Cease and Desist Order Item # 10 Order No. R3-2014-0047

Staff Recommends Adoption of Cease and Desist Order R3-2017-0016

Surface Impoundment Liner System

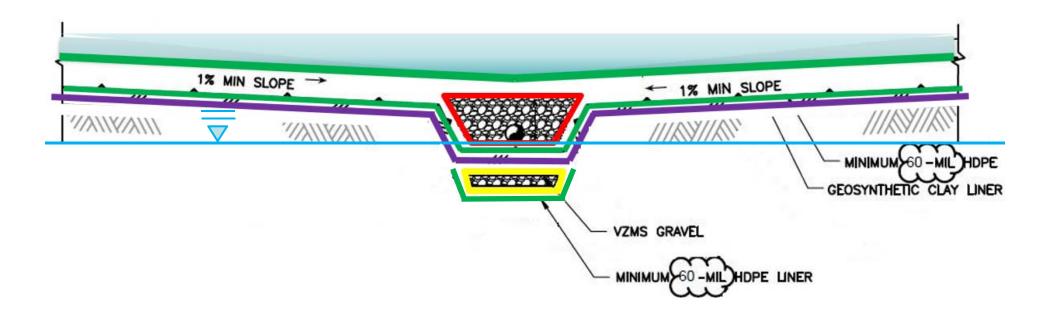
Impoundment Design Flaw #1

The presence of liquid in the VZMS means either:

- 1) The liner is leaking; or
- 2) Groundwater has infiltrated into VZMS

Impoundment Design Flaw #2

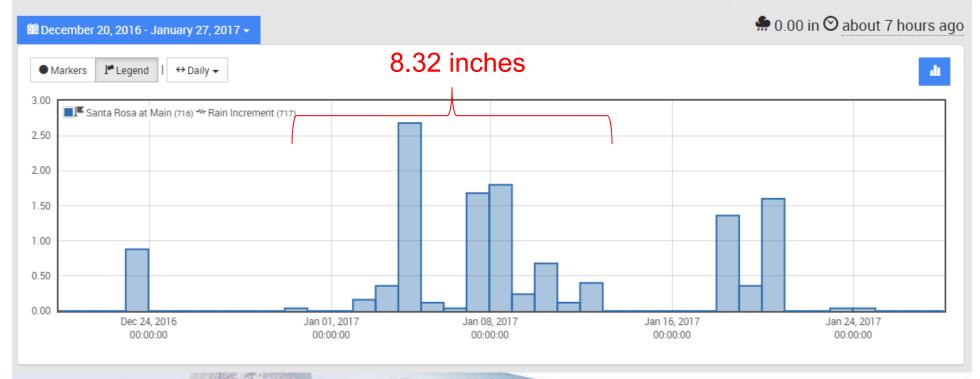
- Surface Impoundment designed to contain a 1,000-year 24-hour storm event
 - -Exceeded minimum freeboard on February 5, 2017 (34.2 inches required)
 - Design Report states:
 - "...there is no anticipated stormwater flow into the evaporation pond." 28
